# **UT to Rush Fork Stream Mitigation Project Mitigation Plan – Final**

DMS Project ID No. 100068, DEQ Contract No. 7535, DMS RFP #16-007335

Re: NCIRT Review and USACE Approval of the NCDMS UT to Rush Fork Mitigation Site /  
Haywood Co./ SAW-2018-01171/ NCDMS Project # 100068

**Subject:** Response to IRT Comments for Draft Mitigation Plan Review  
UT to Rush Fork Stream Mitigation Project, Haywood County, French Broad River Basin,  
CU# 06010106, DMS Project #100068, DEQ Contract #7535.

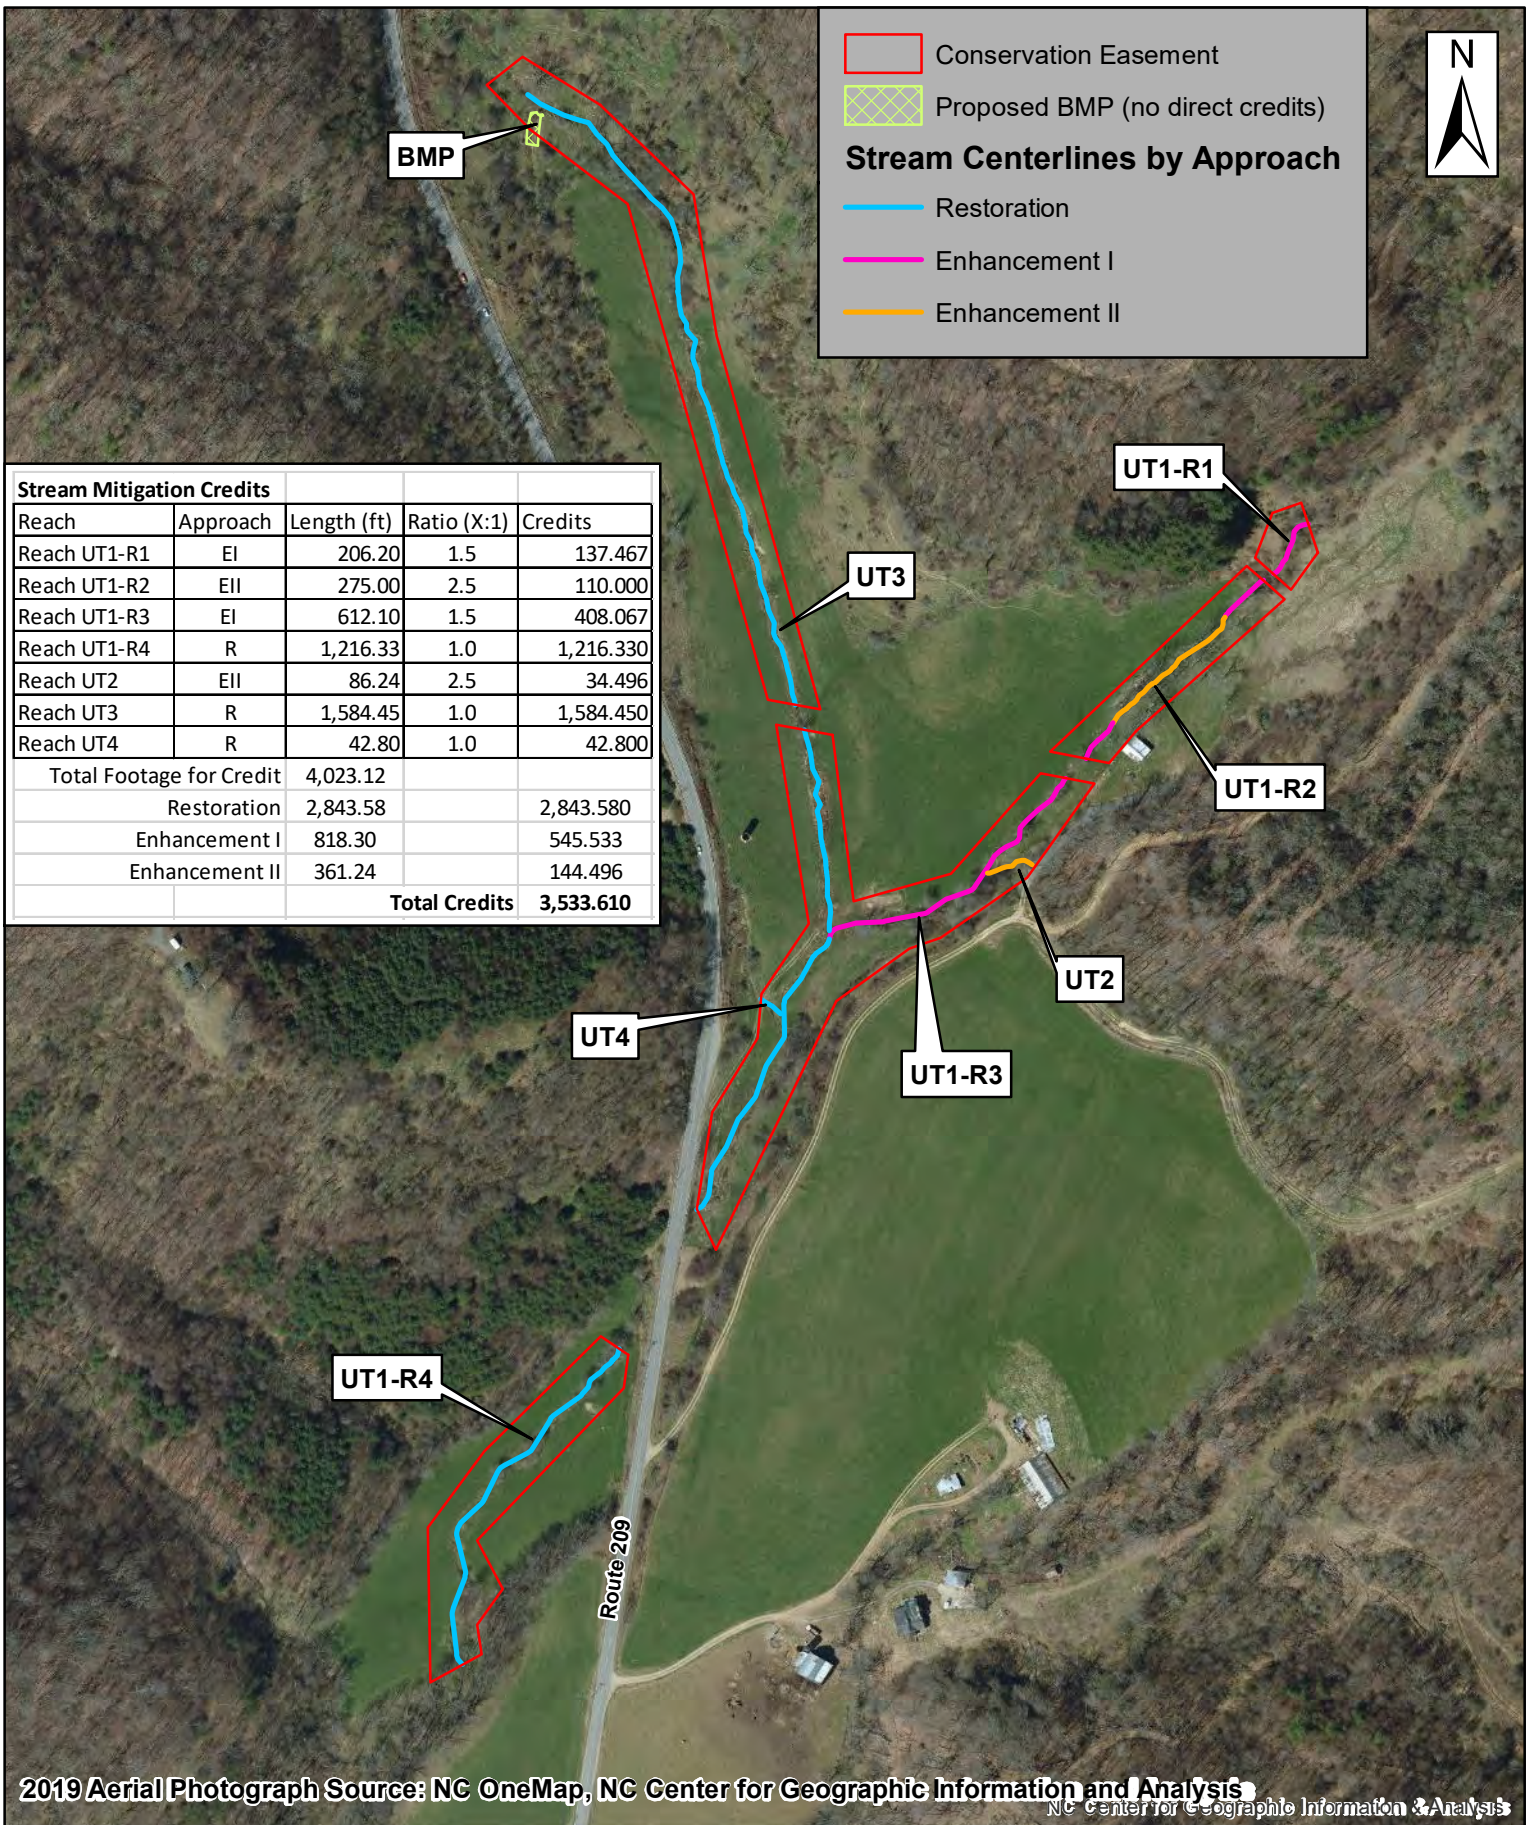
4. Figure 11: Please mark locations of photo points, to include crossings and culverts. If cross-sections are to be used as fixed photo points, please footnote the Figure.

6. Figure 11 – DWR is concerned with the number of mature black walnut proposed to remain within the 300-ft Enhancement II section of UT1 Reach 2. Given that vegetative success is a significant component for EII credit, DWR requires an additional veg plot in this area to document density, vigor, diversity standards are met within the vicinity of the black walnuts.

**Response: Baker will absolutely include annual monitoring photo points at all crossing and culverts for the project. And while the cross-sections will include photos of both banks, they have never been considered part of the project photo points per se, but simply a part of the cross section assessments. Baker will show all photo point locations on the CCPV with the as-built report.**

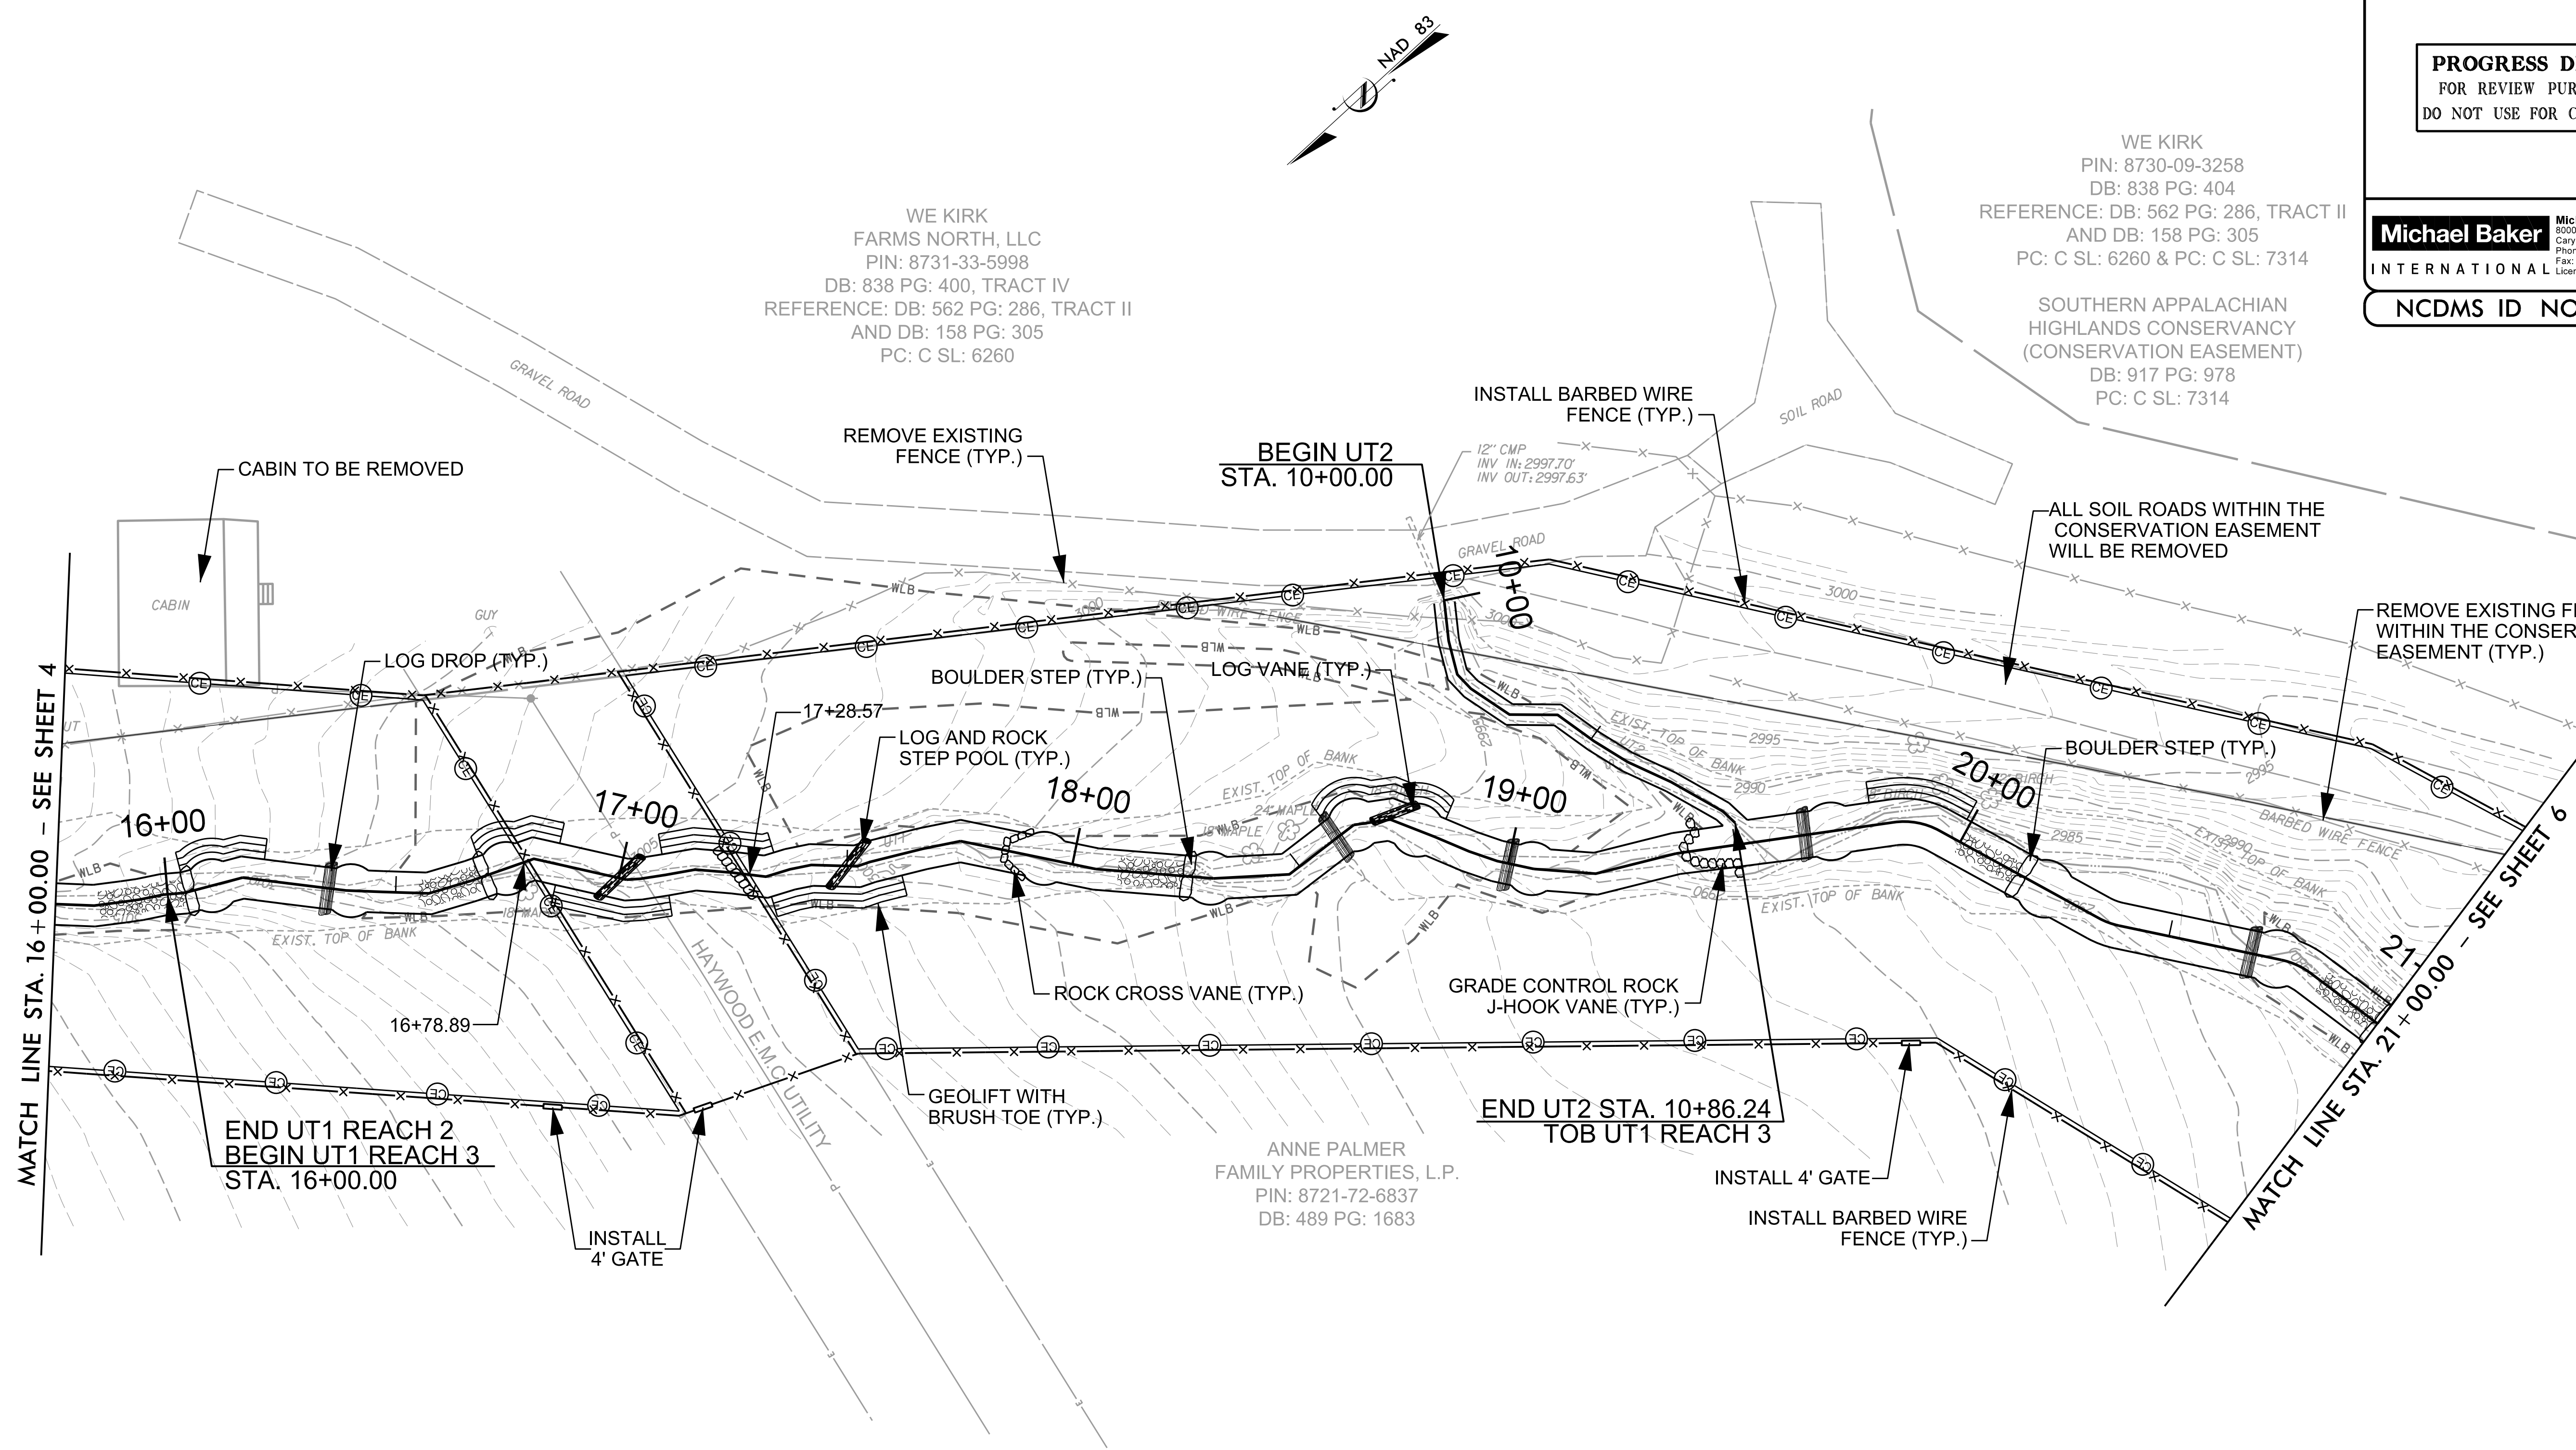
12. Sheet 5 – Does the culvert under the adjacent gravel road extend into the conservation easement? If so, the landowner needs to be aware that maintenance coordination with DEQ Stewardship may be required.

13. Sheets 4 & 5 – Please show/callout all proposed stream enhancement construction work areas, including bank grading, along UT1 Reach 2 and UT2.

**Response: For these two reaches, Sheets 4 and 5 of the plans set have had the existing conditions tops-of-banks line identified with a label. This should more readily illustrate the location and degree of bank**

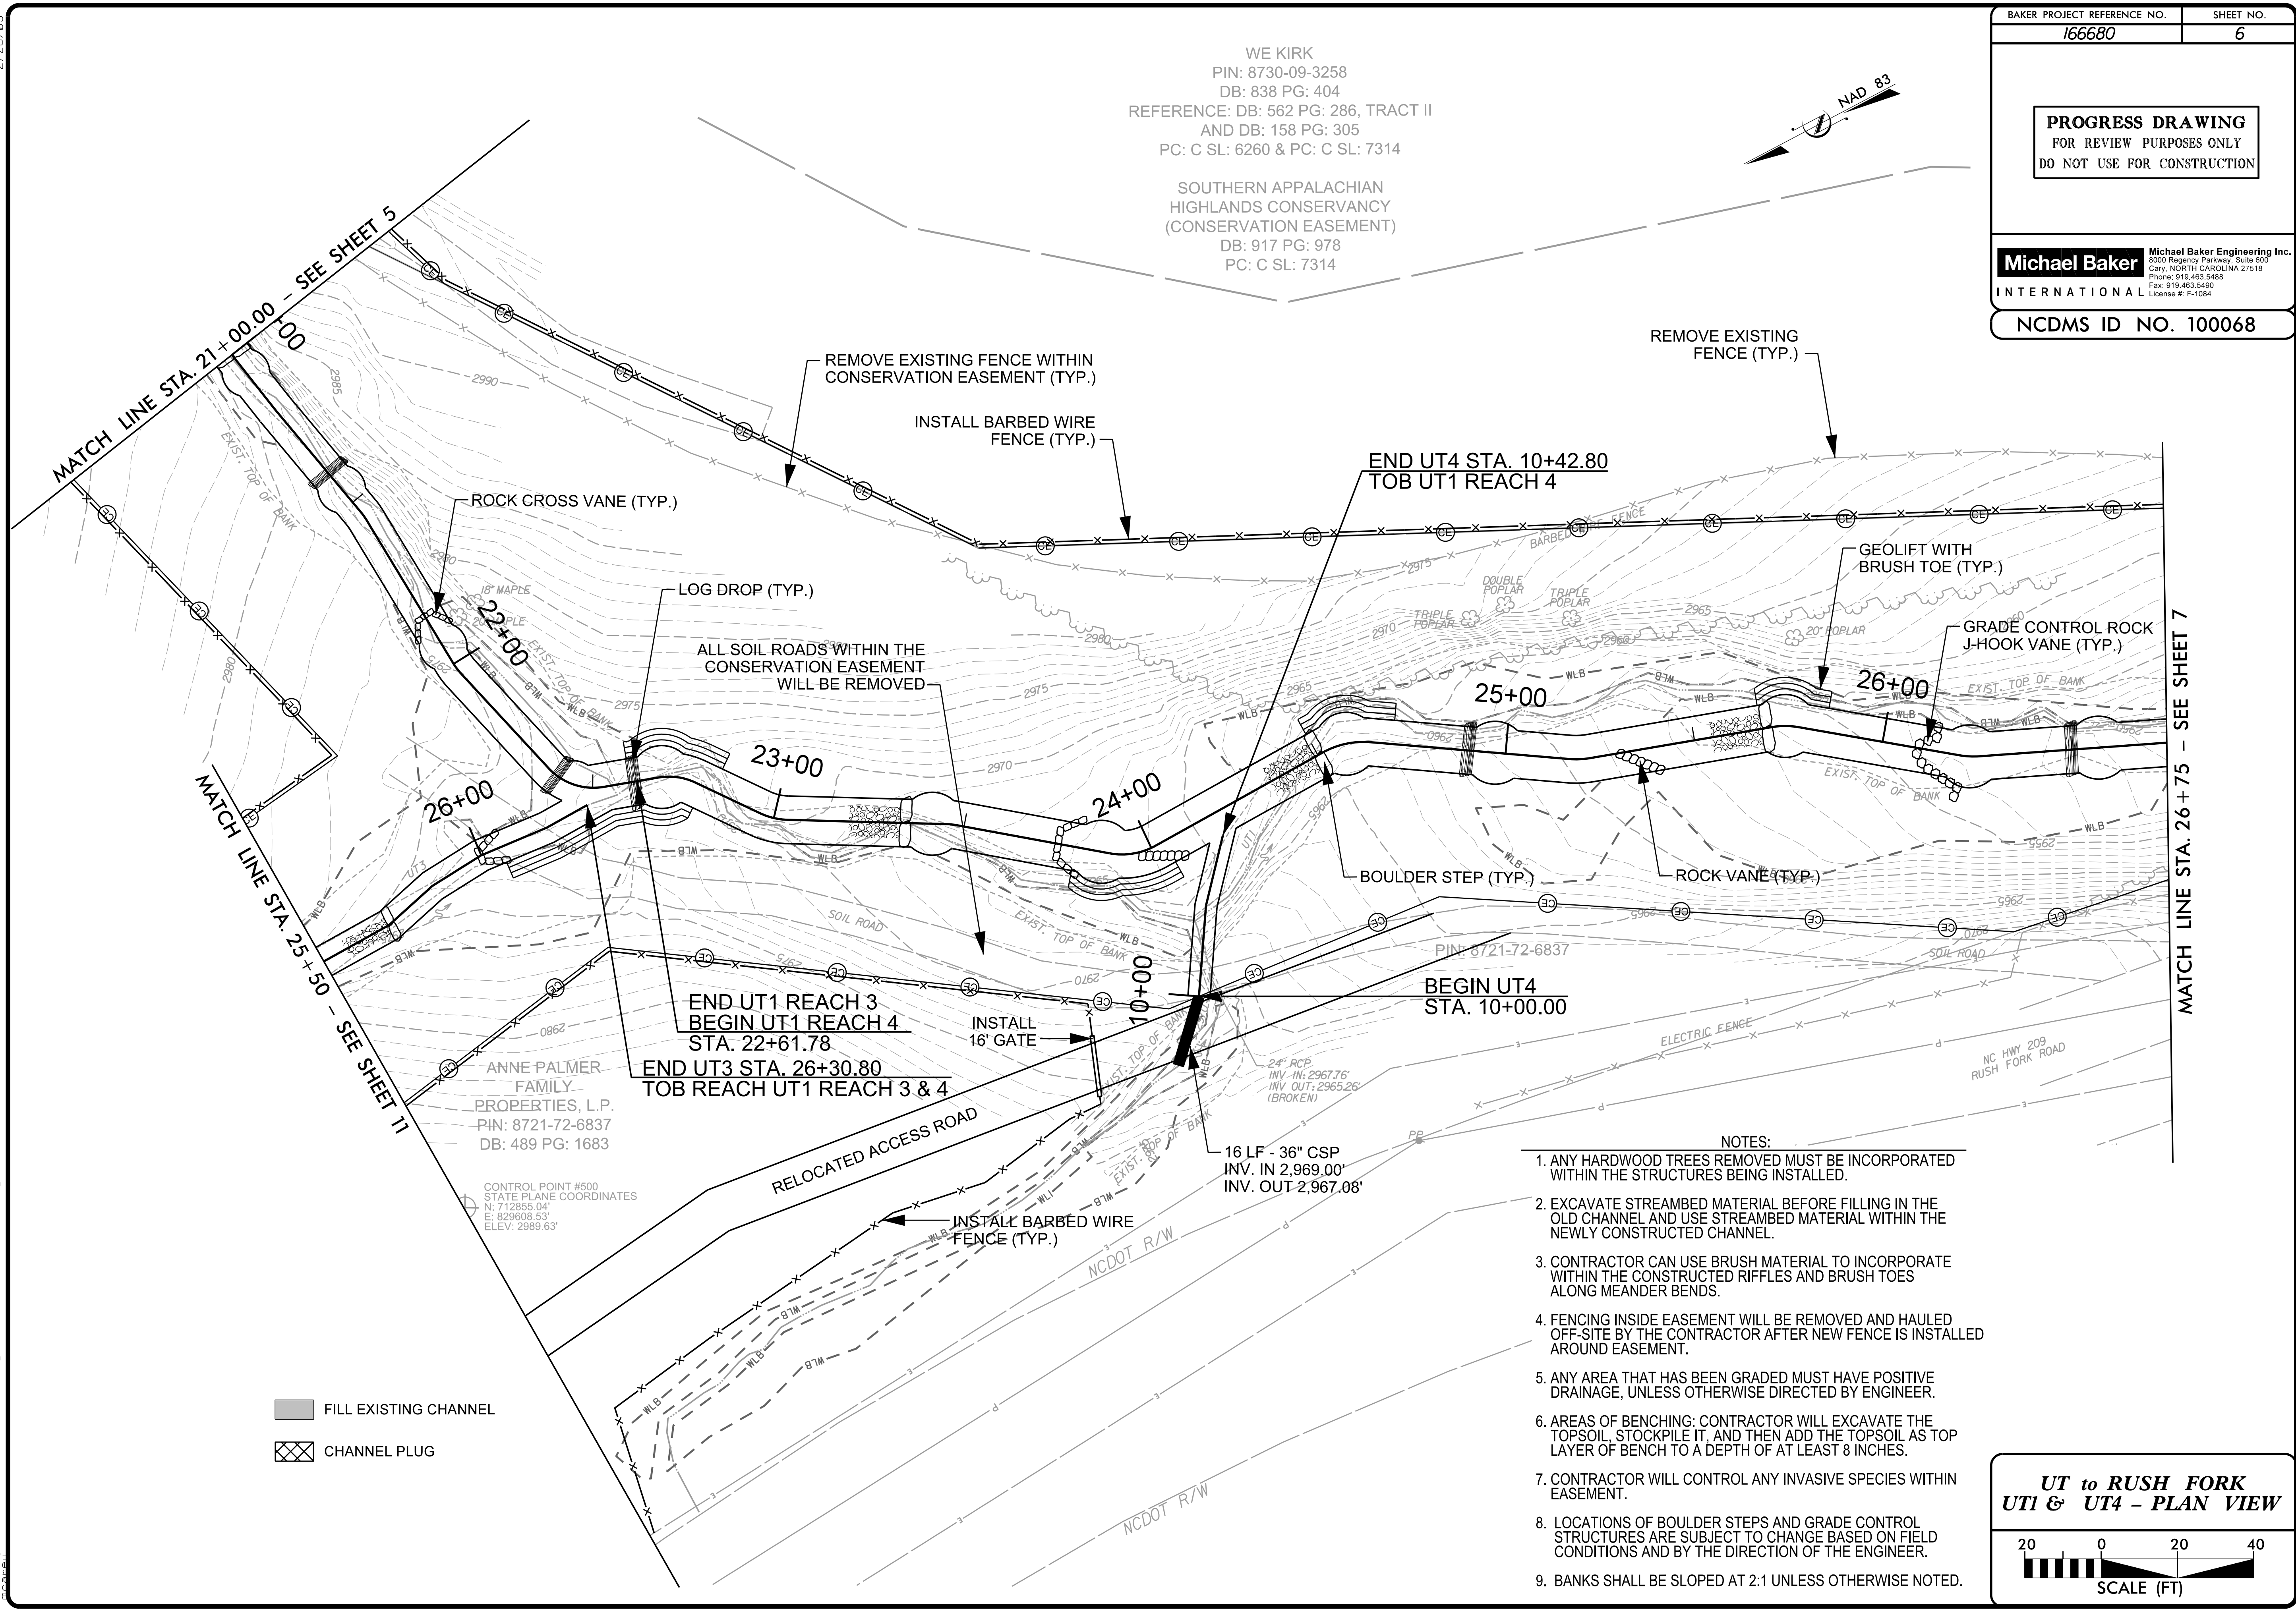
14. Sheet 6 – Please confirm that no structures or bank treatments are proposed for UT4 and that the restoration reach has been designed for long-term stability as shown on the plan sheet. As noted in the above comment, design sheets should show all proposed work. The Mitigation Plan Table 3.1 identifies this reach as a Cb stream classification, correct?
